UMTRA PROJECT OFFICE
PROJECT INTERFACE DOCUMENT

Site Durango, Colorado	Date 12/31/96	PID No. 03-S-41	Site No. 03	Vic Pro No.
Originator and Location Tom Jernings, APO	Phone (505) 766-1667	Organization MK-Ferguson	Answer By:	References: Subcontract: Subcontract No: DUR-86-02
Subject Extension of Subcontract Completion Date

U. S. DEPARTMENT OF ENERGY
ALBUQUERQUE DISTRICT OFFICE
NUNATAK SITE
MOJO CANYON DISPOSAL SITE
EMBANKMENT EROSION PROTECTION

Site Durango	Date 8/09/90	PID No. 03-S-30	Site No. 03	Vic Pro No.
Originator and Location M. L. Wesely, SF	Phone 415/442-7511	Organization MKES	Answer By:	References: Subcontract: Subcontract No:
Subject Redesign of the Ditch No. 1 Outlet and Two Drainage Outlets Along Ditch No. 2

FIGURE 1: PLAN VIEW OF AREAS TO BE REVISED PER P.L.D. 03-8-80

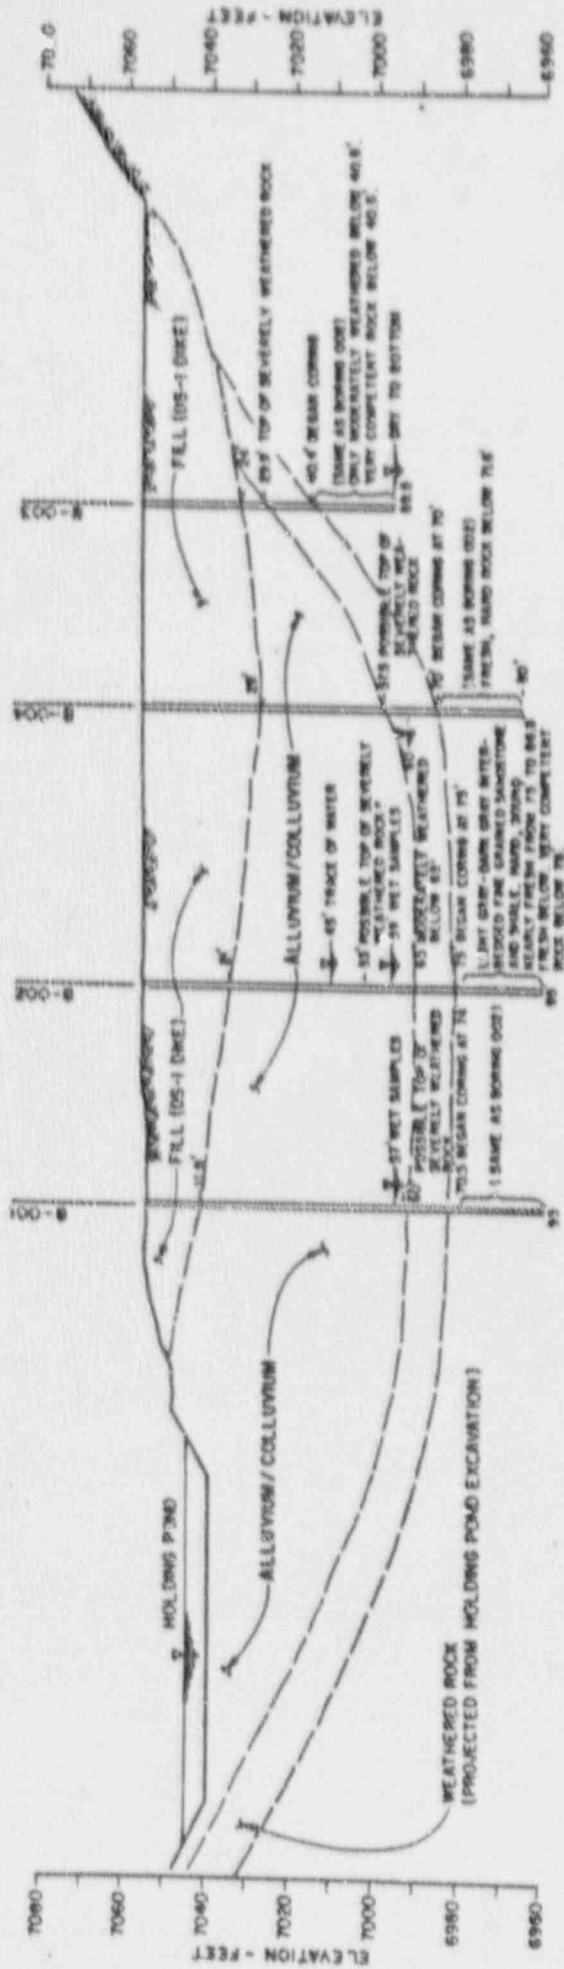
PROBLEM 1: A drilling program was completed in June to help delineate the bedrock locations in the region of the Ditch No. 1 outfall. The plan view and profile of the outlet area are shown in Figure 1 and 2, respectively. The depth to bedrock at the outlet of Ditch No. 1 is much deeper than originally anticipated. If the original design to key into competent bedrock was implemented, the excavation of the outlet would cut into the adjacent observation wells (see location of wells in Figure 3) and undercut the existing holding pond embankment which contains the discharge water of the toe trench. It would also form a large reservoir for water exiting the ditch and affect the groundwater regime in this area.

FIGURE 4: REDESIGN OF DITCH NO. 1 OUTLET

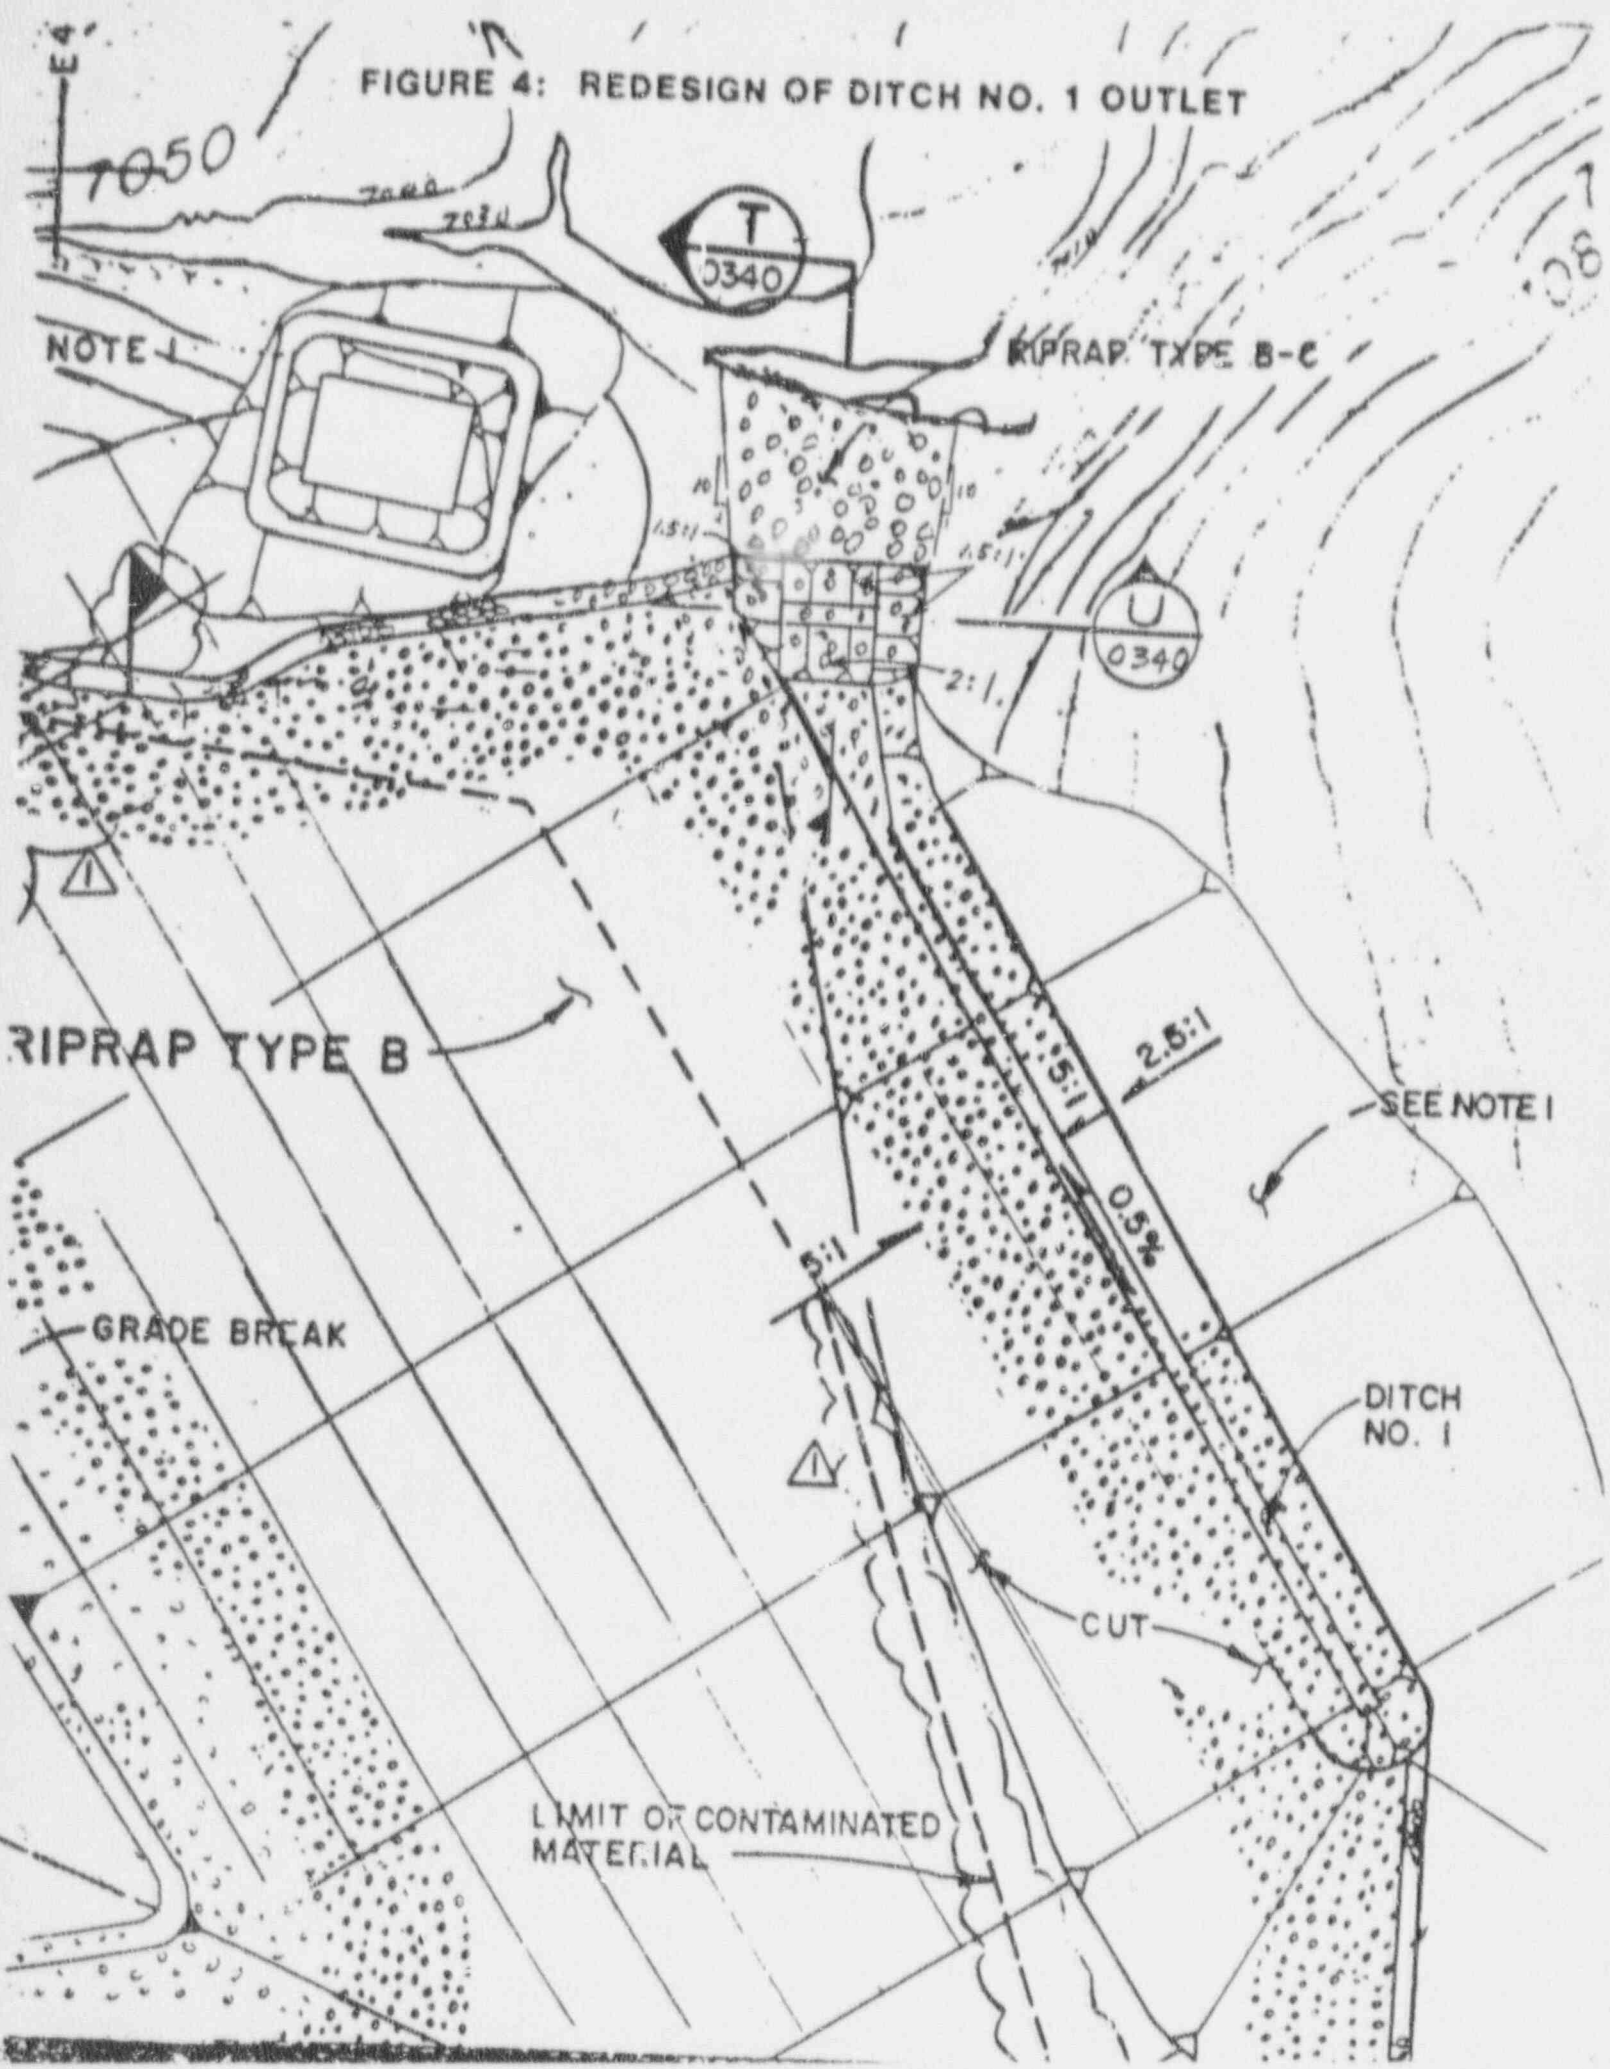
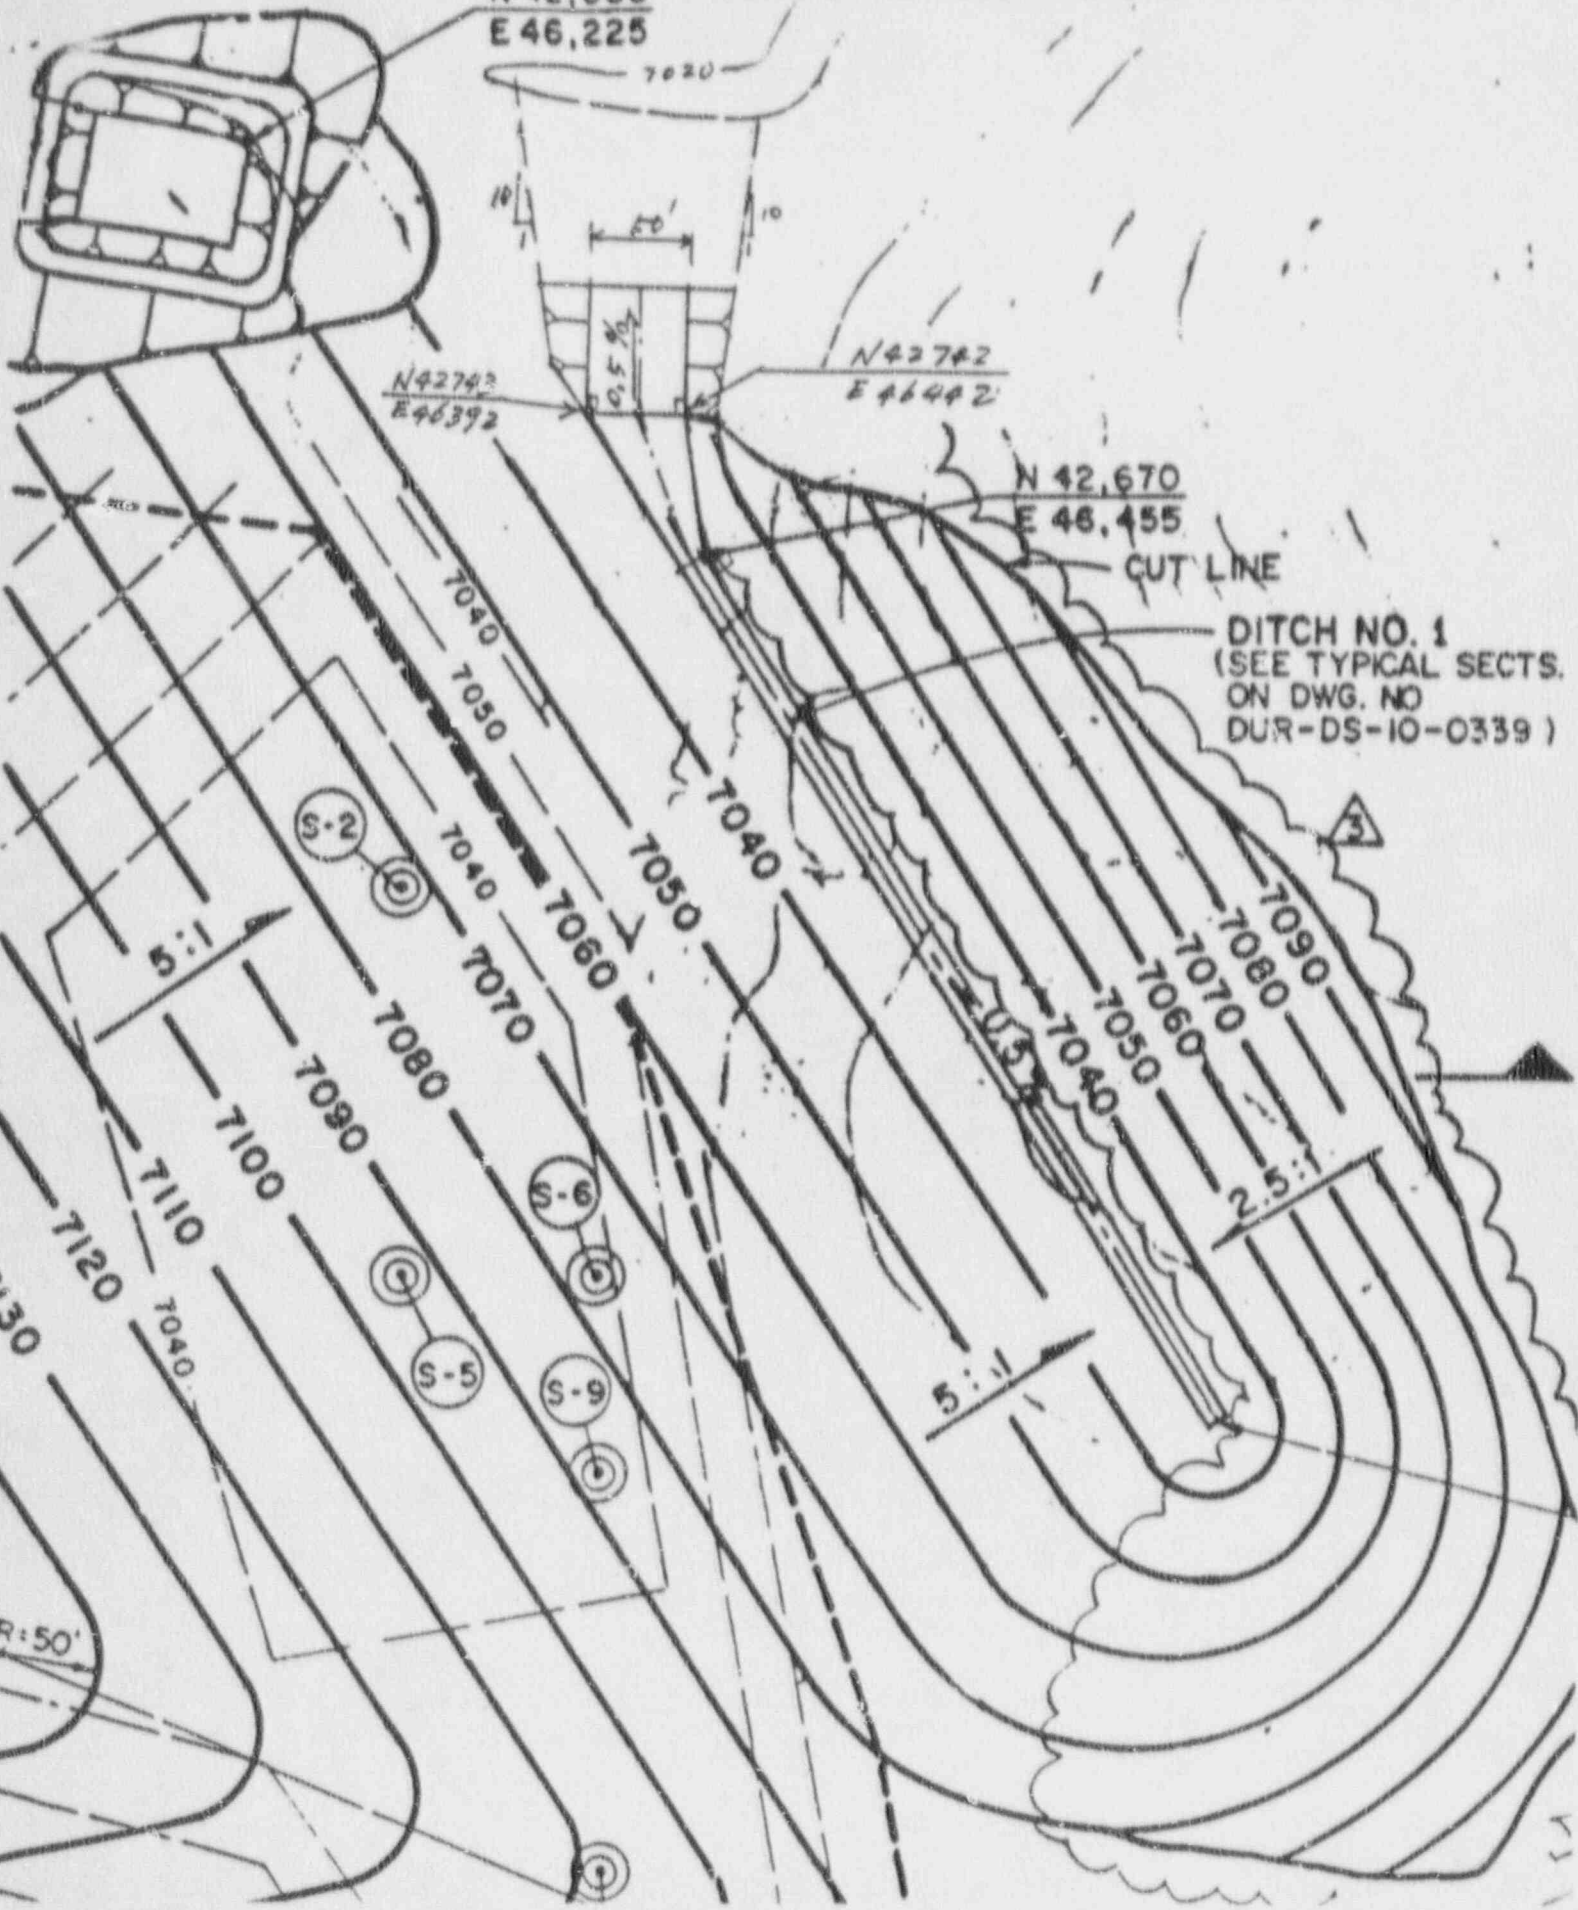
Design of the outlet structure was reevaluated to determine what volume and size of rock would be required to maintain erosion protection for water discharging from Ditch No. 1. The attached drawings (Figures 4, 5, and 6) and supporting calculations present the proposed revisions. Changes include:

- o Removal of the words "key into bedrock",
- o Slope from ditch into outlet box steepened to 2:1 and subsequent shift of outlet further away from the northern drainage channel.
- o Addition of a rock apron from the far edge of the outlet to the northern drainage channel to prevent gully initiation from water exiting the outlet box,
- o Regrade slope of natural ground towards northern drainage channel to approximately 8:1, and
- o Continue 1 foot of Type B riprap from ditch across top of outlet box.

SOLUTION 1: Revise the outlet structure on Drawing DUR-DS-10-0337 per Figure 4, revise the end of Ditch No. 1 on Drawing DUR-DS-10-0335 per Figure 5, and revise Sections T and U on Drawing DUR-DS-10-0340 per Figure 6. Add the following note to Drawing DUR-DS-10-0340:

"2. Riprap for the apron from the edge of outfall to natural drainage channel shall be Type B-Type C approved designated waste riprap from Wheeler Pit screening operations with approximate size range of 6 - 16 inches."
